# Franklin Township

## Township Technical Review Committee (TRC)

To: Zoning Board of Adjustment  
From: Technical Review Committee (TRC)  
Date: April 1, 2021  
Re: Saurabh & Abhisha Desai – Backyard Pool - “C” Variances (ZBA-21-00006)  
3 Corwen Ct. (Block 424.11, Lot 10)

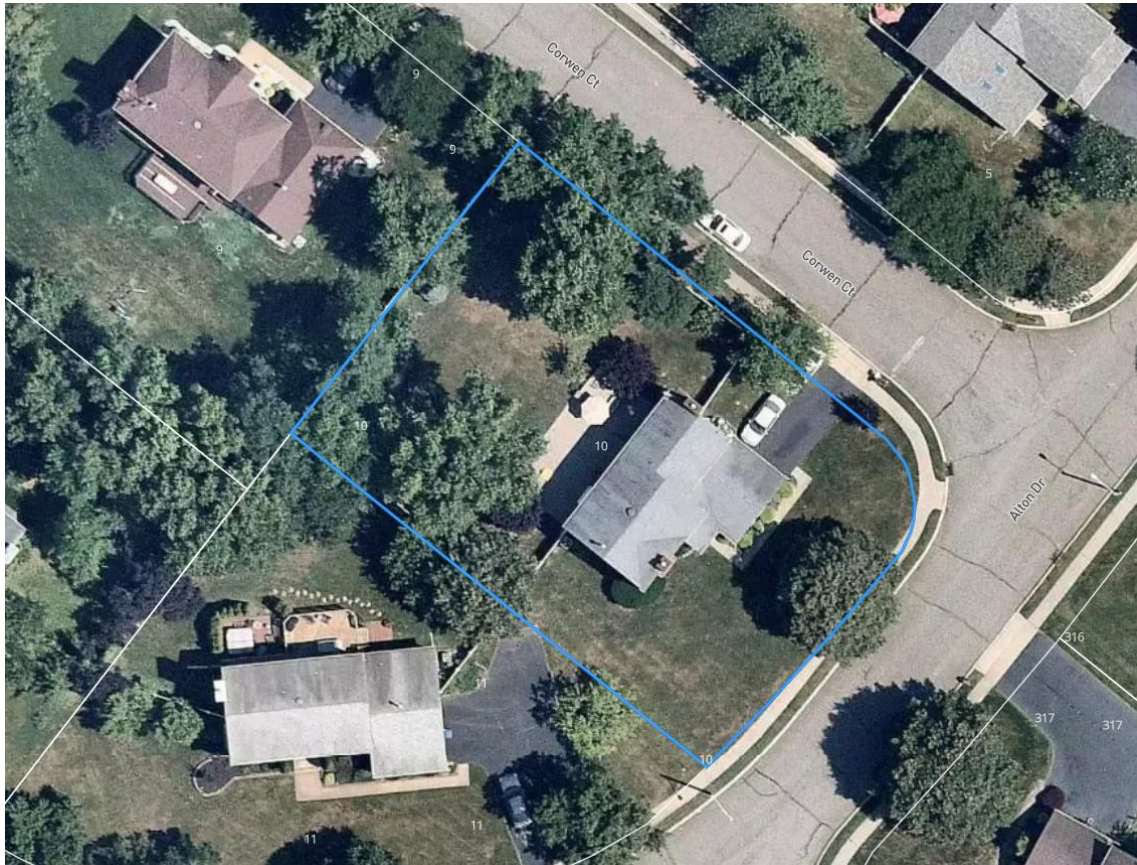
1. If the applicant seeks to address this as a hardship (i.e., a C-1 variance) then they should address why the pool couldn't be placed in a compliant or more-compliant location.

Alternatively, the applicant will need to prove that the proposed location would represent a better zoning alternative than compliant placement of the pool such that the purposes of the Municipal Land Use Law (MLUL) would be advanced (i.e., a C-2 variance).

- 2. As the site proposes additional impervious surface of approximately 1,600 square feet of disturbance Chapter 330, Stormwater Management, of the Township ordinance will apply. The application will be reviewed for consistency at the time of building permit submittal. Such review will include the design/ placement of the retaining wall and possible impact of surface water runoff onto adjoining properties. The applicant should note that the stormwater system shall be installed a minimum of 10 feet from any property line.
